Development Services Committee – May 9, 2022

Proposed Revision to Draft Approved Plan of Subdivision (18T-94025, Phase 9) –
Greycrest Homes – West of Harmony Road North, north of Greenhill Avenue
(Ward 1) (File: 18T-94025)

Subject: Proposed Revisions to Draft Approved Plan of Subdivision (18T-94025 Phase 9) – Greycrest Homes

Item: DS-22-91
 Attachment 2

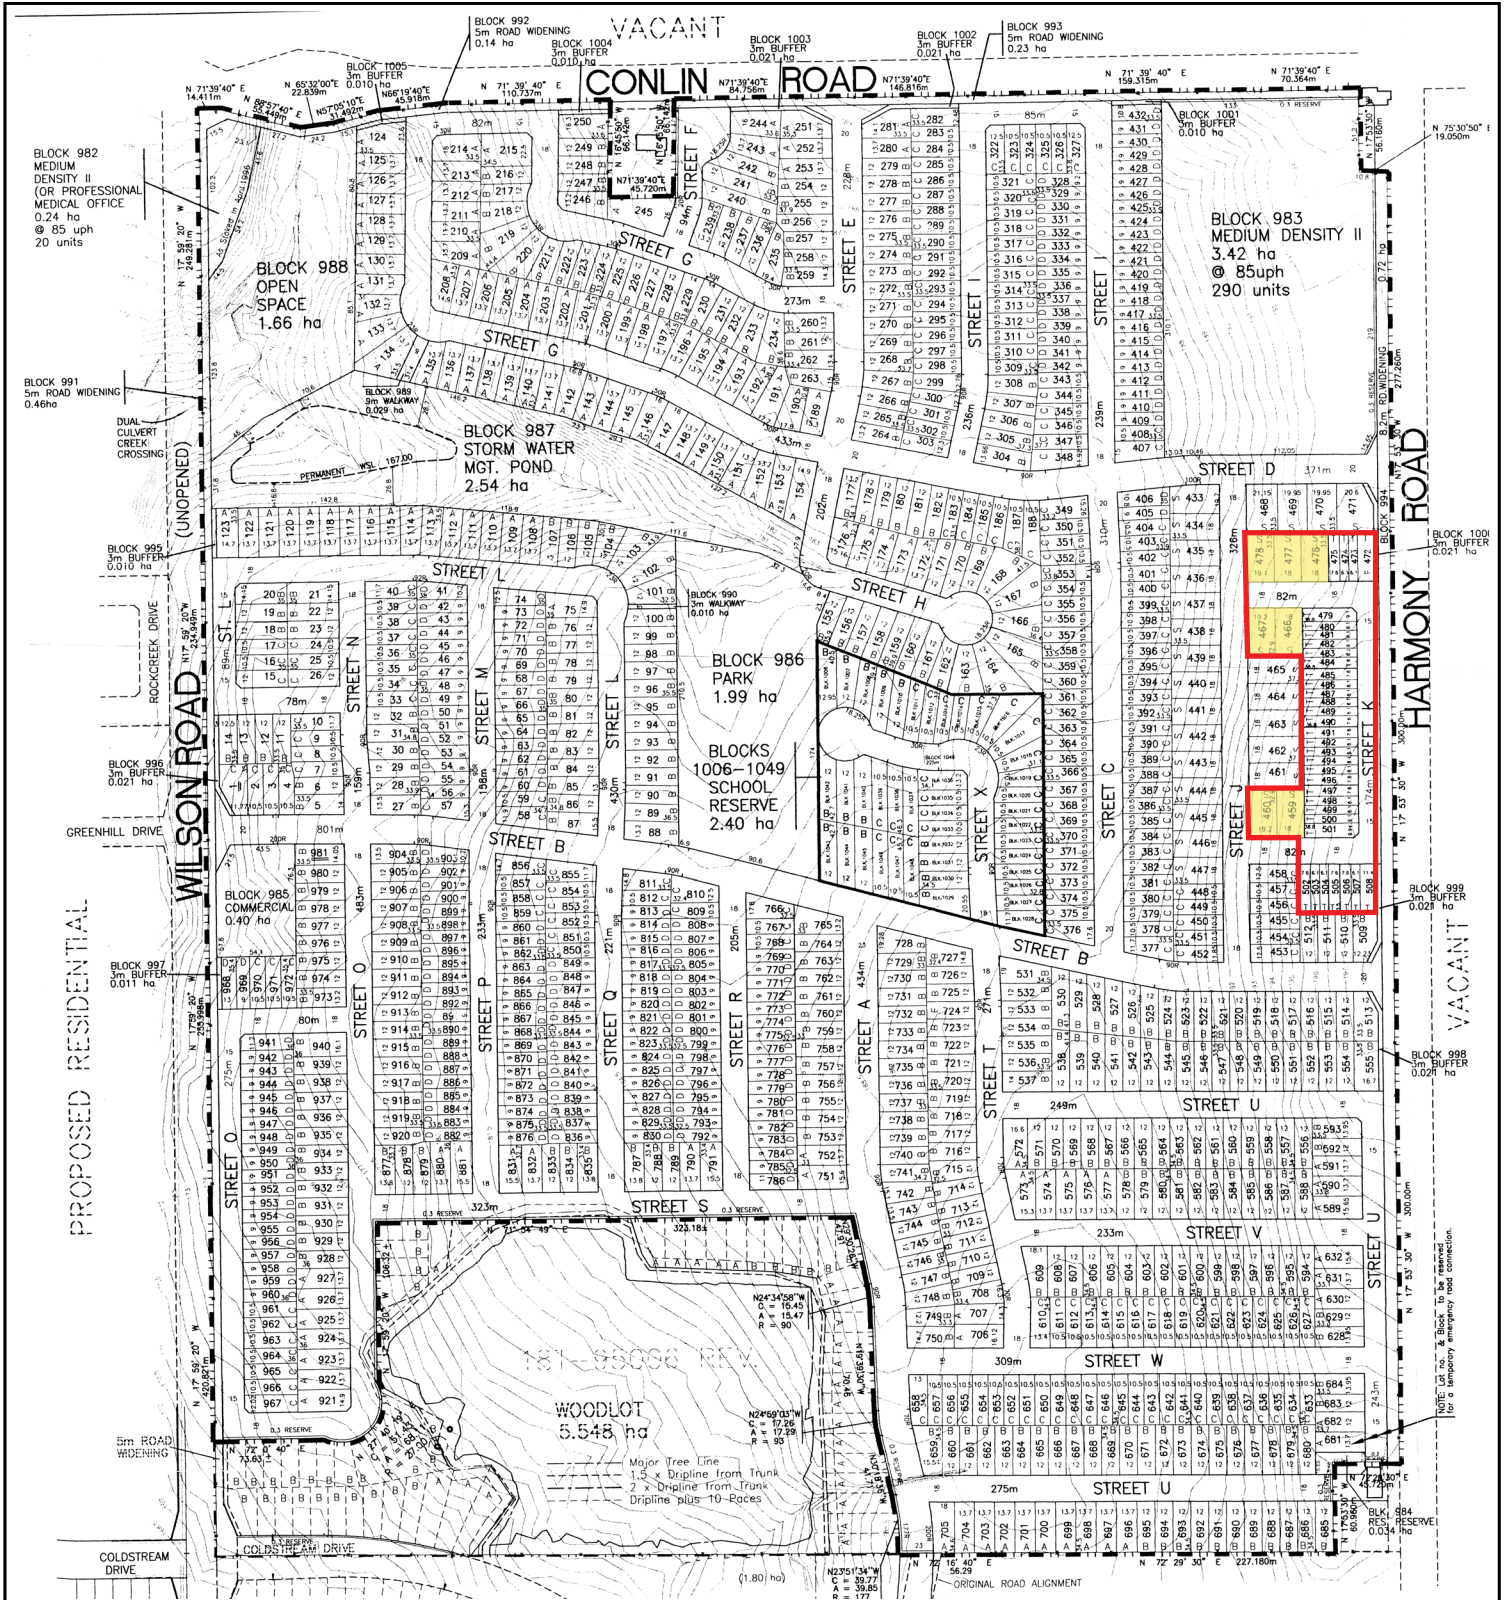
Whereas the semi-detached building lots proposed to be converted to single detached dwelling lots through this proposed revision consist of Lots 459, 460, 466, 467, 476, 477 and 478, shown on the draft approved plan of subdivision 18T-94025 (see Attachment 2) and shown as Lots 1 to 14, all inclusive, on the draft 40M-Plan for Phase 9 (see Attachment 3); and,

Area of Semi-Detached Lots Proposed to be Converted to Single Detached Lots
 Area of Proposed New Draft 40m Plan (Phase 9 of Subdivision File 18T-94025)

Therefore, pursuant to DS-22-91, the proposed revisions to Phase 9 of Draft Approved Plan of Subdivision 18T-94025 to accommodate single detached dwellings on lots previously proposed for semi-detached dwellings be approved, and that the proposed
